Planning Commission Regular Meeting | March 17, 2026

Re: Appeal of Director Determination for 333 26th Street

This is an appeal of the Director's Determination dated January 28, 2026, that the survey of 333 26th Street does not demonstrate a convex slope under the Hermosa Beach Municipal Code (HBMC). We request that the Planning Commission review the site survey and the results of the geotechnical report for the site and determine that 333 26th Street has a natural convex slope, and the grade of the lot is the grade shown on the survey, reduced for the depth of fill soil.

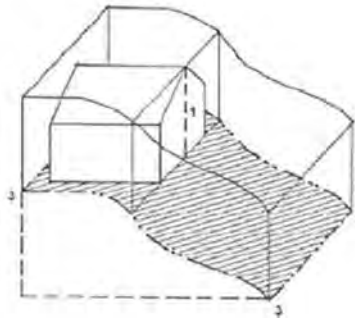
1) The survey does show that the ground arches upward along a property line.

The survey of 333 26th Street shows a classic convex sloped lot. The grade of the lot is a literal arch above the interpolated (straight-line) grade that rises along the property line in each direction until reaching the highest point of convexity.

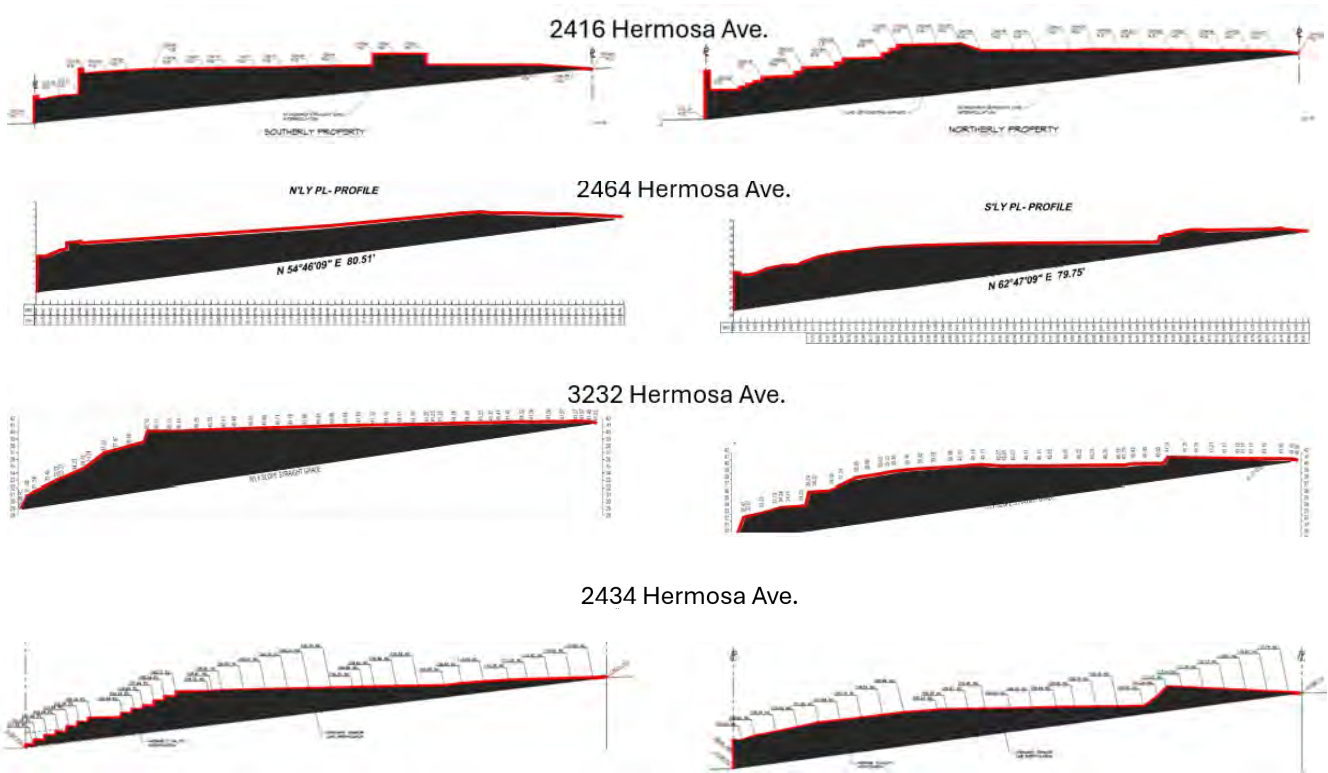
The Director appears to have concluded that 333 26th Street is not convex, because it does not resemble the following diagram in the City’s handout on convex lots.

In fact the subject site *does* resemble this diagram, but with the convexity elongated towards the middle of the lot rather than confined to the rear. The Director even acknowledges that there is a “mid-lot slope” at 333 26th Street when she notes that the “the mid-lot slope” will be altered by grading. Nothing in the code states that a convex slope can occur only at the rear of a lot, and none of the Planning Commission’s prior convex slope findings have reflected this idea. For instance, one street over, the Planning Commission found the following lot to be convex. This lot has points of convexity in the front and the middle.

Discount of Fill Soil

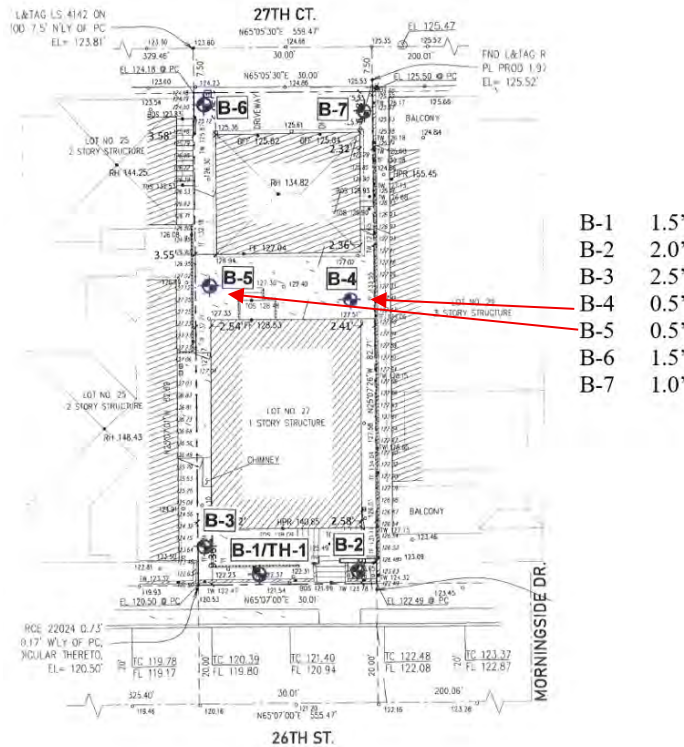
A geotechnical engineering investigation for the site indicates the extent to which the elevation of the existing grade is due to fill soil. In a report dated October 30, 2025, NorCal Engineering presented data from seven boring holes on the site, labeled B-1 through B-7 on the diagram below, showing the following levels of fill at each boring site.

At the boring sites nearest the highest points of convexity, B-4 and B-5, the report indicates 0.5' of fill soil. Based on the relatively uniform rate of rise towards the points of convexity, we believe it is reasonable to conclude that a fill layer of 0.5' or less spans the entire convex portion of the lot. Accordingly we ask that you find that the elevations on the easterly and westerly property lines depicted on the topographical survey -- less 0.5' to account for fill -- may be used to determine the height limit for the subject lot.

333 26th St. Soils Report

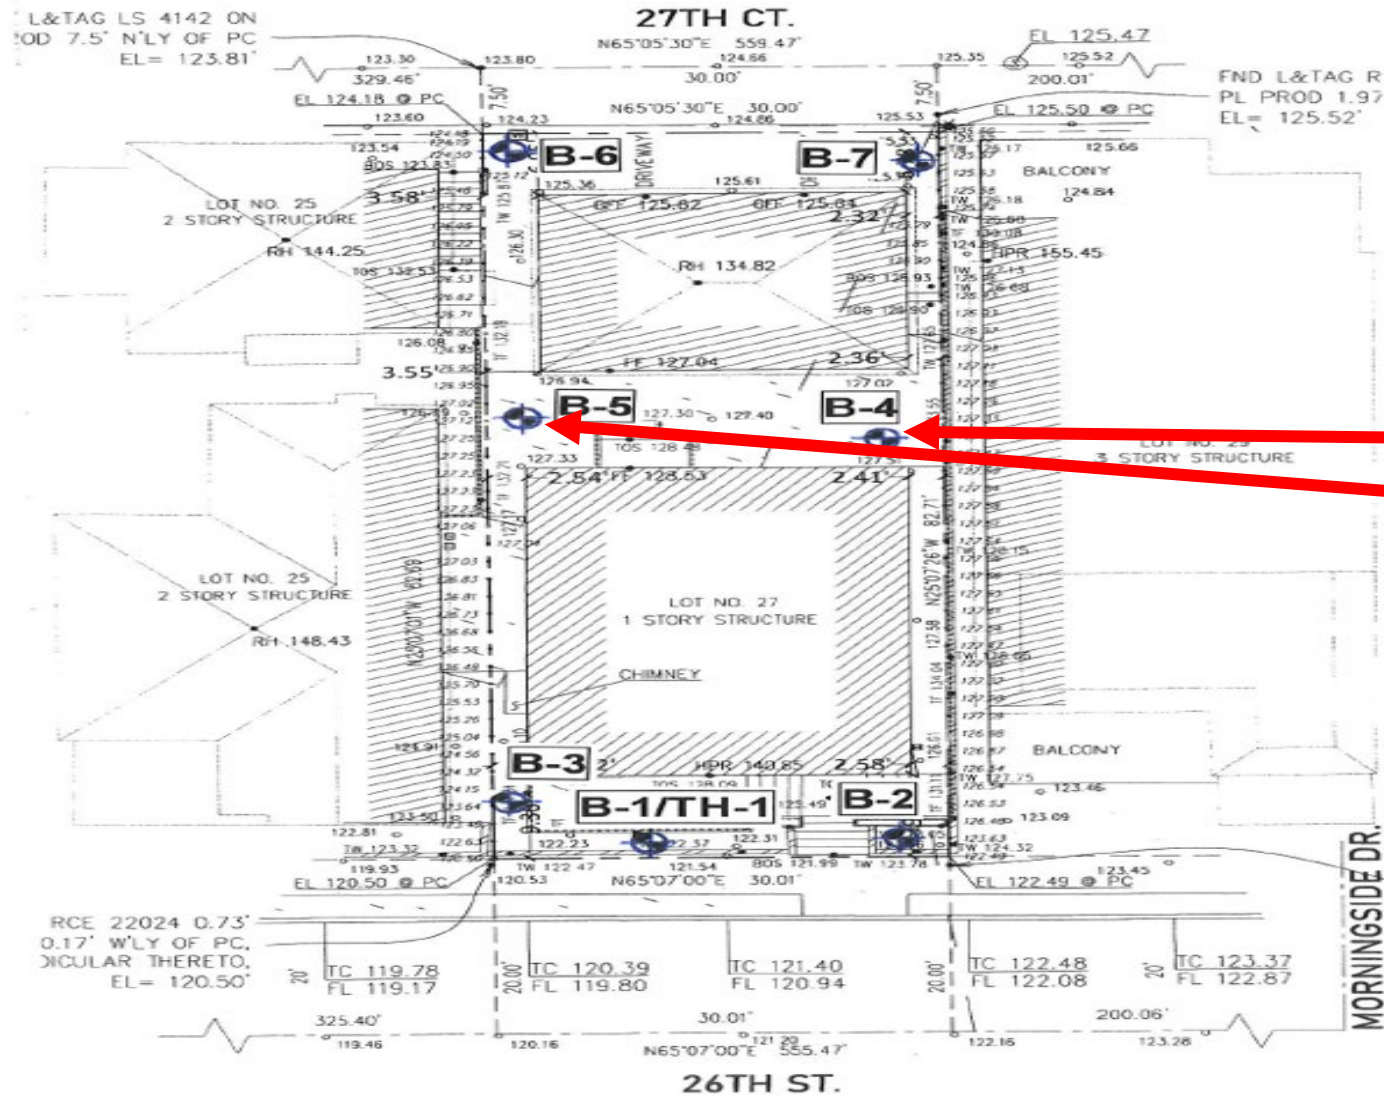
Depth of Fill Soil

B-1	1.5'
B-2	2.0'
B-3	2.5'
B-4	0.5'
B-5	0.5'
B-6	1.5'
B-7	1.0'

- Based on these 2 documents, the Appellant requested:
 - the City find that convex slope did exist on this lot, and
 - elevations on the property lines be used as the grade of the lot, less .5' to account for the fill soil
- This two-step analysis has been the basis for convex lot determinations for **at least 15 years**

Consistent Convex Arch Slope with 301 27th to 333 26th

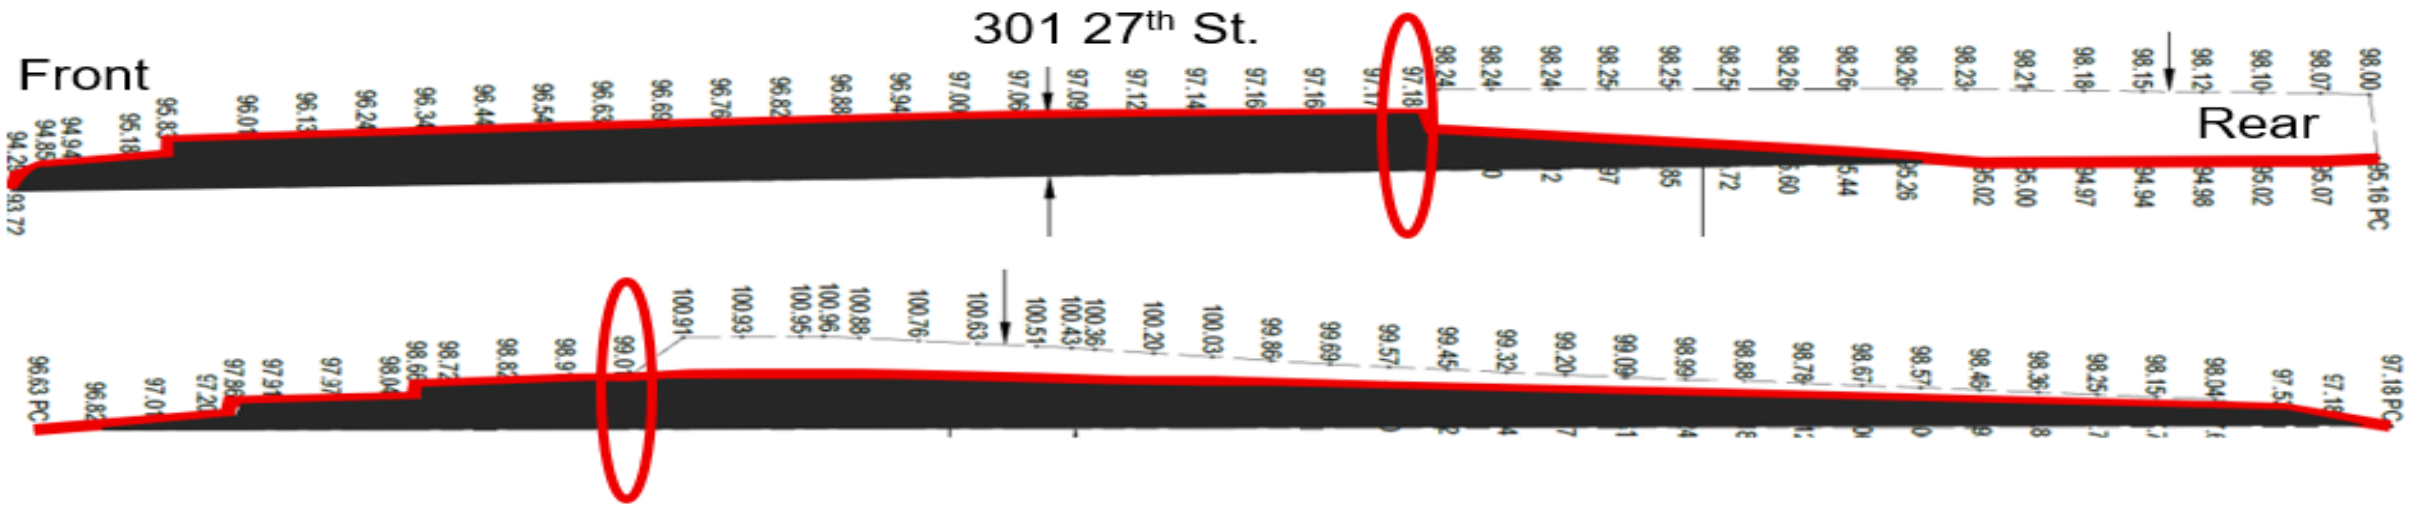
301 27th has smaller grade of ~2 feet compared to 333 26th with ~5 feet

The City Director's Denial of Convex Slope (cont.)

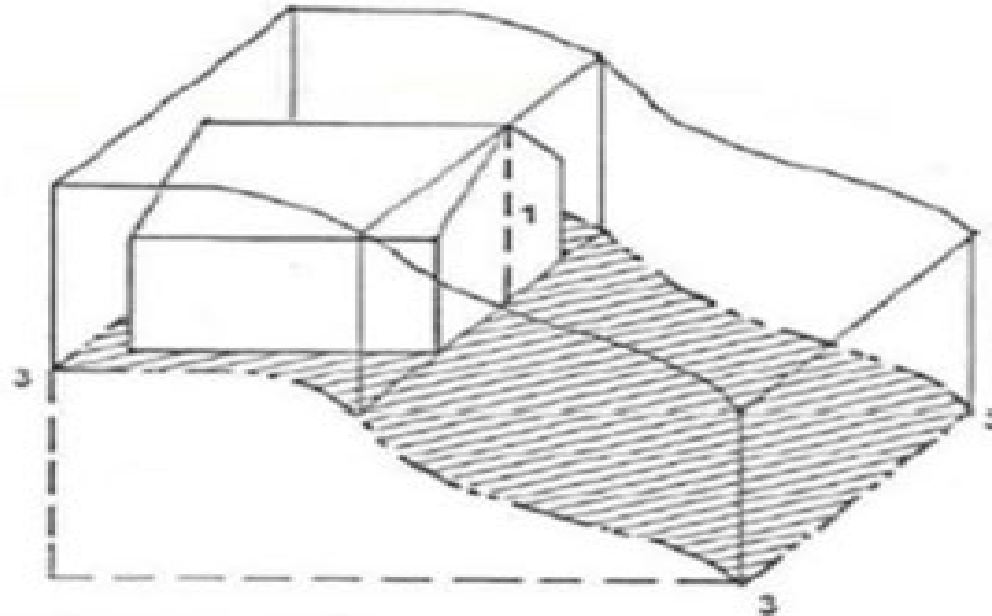
- Director denied because lot does not resemble the below diagram
- The Director/Staff presented *proposed* interpretation in the February Planning Commission meeting used on Appellant's denial, which is intended for *future applicants*
